DOCUMENTATION TRANSMITTAL

Documentation Description: Nonconformance Reports: C-03018
C-02181
C-02818-HV

NONCONFORMANCE REPORT

1 ITEM LOCATION <u>3'-4" North of G6, 11'-2" West of G 7.4</u> <u>Aux. Bldg. Room No. 118, Area 120D, Elevation 584'-0"</u>		
2 ITEM DRAWING/PART NO. <u>Rev 3</u> <u>FK-M-2-HBC-552-1-H1</u>	3 ITEM PART NAME <u>Small Bore Pipe Support</u>	4 ITEM SERIAL NO. <u>N/A</u>

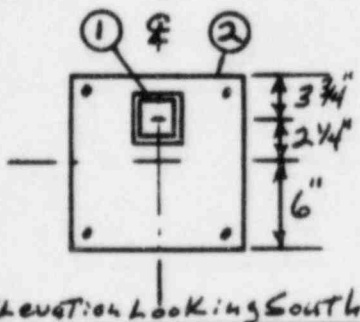
13 NONCONFORMANCE 1) Contrary To Design Drawing, Note #2, Item #1 Is Not Centered On Base Plate. & Item #1 Is 3 3/4" From Top Edge Of Base Plate (Item #2).

2) Contrary To Spec. M-326 ^(A) Para. 5.1.6.1: A Gauge
Exists In Item #1, Greater Than $\frac{1}{32}$ " Deep; Gauge Is 2"
North of Item # 6 On Bottom Face of 3X3" T.S.

1) Use As Is: Project Engineering TO Evaluate Design As Installed.
2) Repair: Repair Item #1 Per. Spec. M-326 ⁴ Para. 5.16.2.

ITEM #1 PROJECT ENGINEERING CONCURS WITH THE FIELD ENGINEERING RECOMMENDED DISPOSITION TO 'USE AS IS'. DRAWING FSK-M-2HBC-552-1-HIC(R) R.5 AND CALCULATION 400-4077(R) R.4 HAVE BEEN ISSUED TO REFLECT AND QUALIFY INSTALLED CONDITION AS DESCRIBED IN BLOCK 13 OF NCR.

ITEM #2 PROJECT ENGINEERING CONCURS WITH THE FIELD ENGINEERING DISPOSITION TO 'REPAIR'.

CUSTOMER/CONTRACTORS	POWER CO
ORDER OR CONT. NO. 7720	
JOB NAME/NO. AND PLANT UNITS 1, 1, 2	
MARK NO.	
SKETCH NO. FSK-M-218C-55Z-1-H3 (0)	
SHEET 1 OF 1	REV. 3

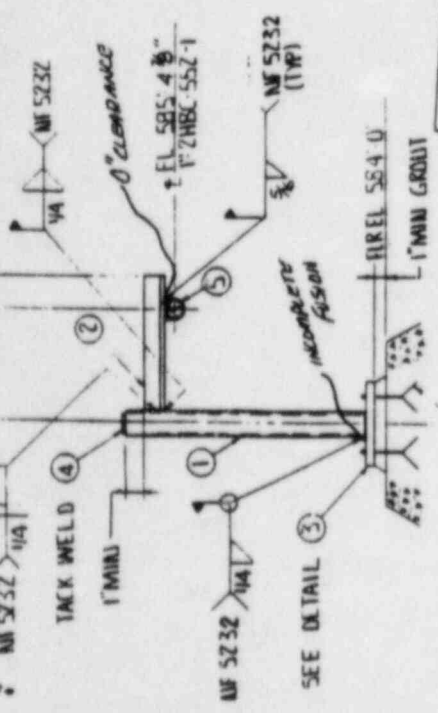
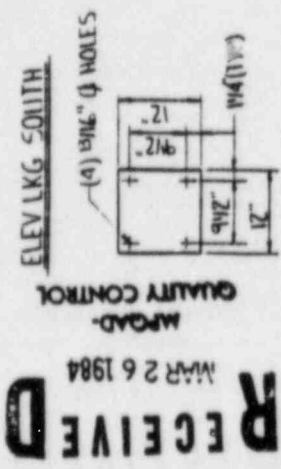
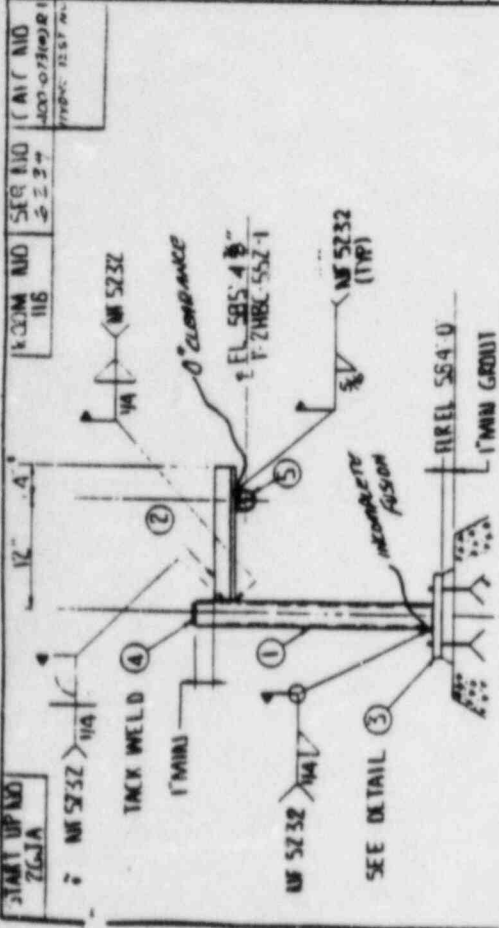
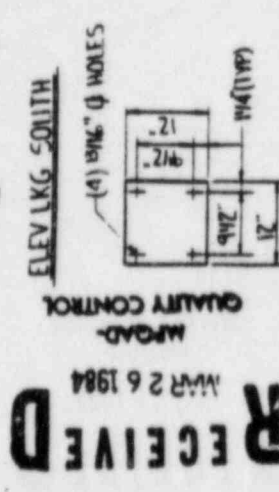
12 REQUIREMENT 1. PQCI P230/5 PARA 3.4.3 b CN# P230-05-1 STATES: "THE COMPLETED WELDS SHALL BE VISUALLY FREE OF CRACKS, OR OTHER LINEAR INDICATIONS." (M326, 20, NF5360).
 2. PQCI P230/5 PARA 3.4.3 b ^{CAS 4-14-84} (M326 3.8.2 (OW6)) STATES: "VERIFY CLEARANCES OF P65 STRAPS AND CLAMPS AS PER P65 DRAWING/HANGER SKETCH."

13 NONCONFORMANCE 1. AGAINST THE ABOVE, THE SOUTHEAST EDGE OF WELD OF ITEM 1 TO 3 HAS AN 1/8" LONG AREA OF INCOMPLETE FUSION.
 2. CONTRARY TO THE ABOVE, THERE IS 0" CLEARANCE BETWEEN PIPE AND TOP/BOTTOM OF SUPPORT - P65 DRAWING CALLS FOR A MIN OF 1/16" (+1/60" / -1/32")
